REMARKS

Redline copy of formal drawings submitted to Draftsperson

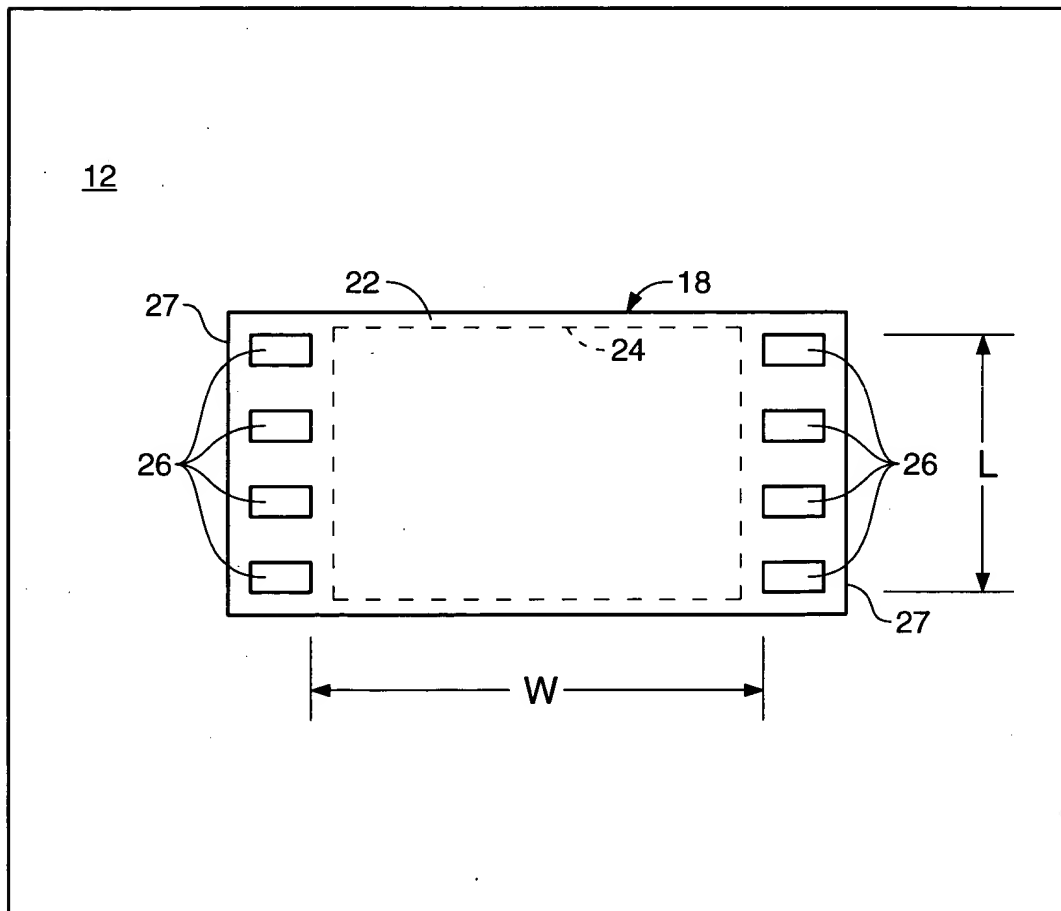
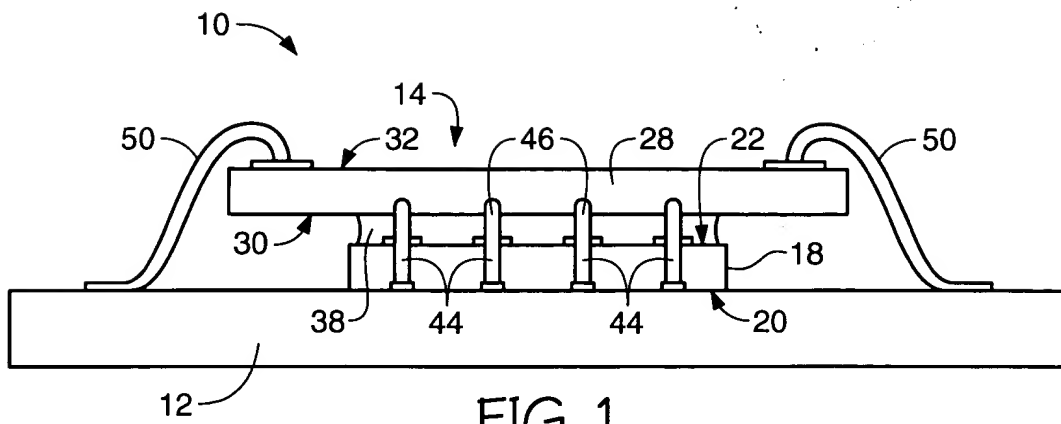
The drawings are objected to.

Per the Examiner's comments, Applicants are submitting substitute formal drawings to the Draftsperson that include references to elements 58 and 60. For the Examiner's convenience, Applicants have included a redlined copy of these drawings in an appendix to this Amendment and Response.
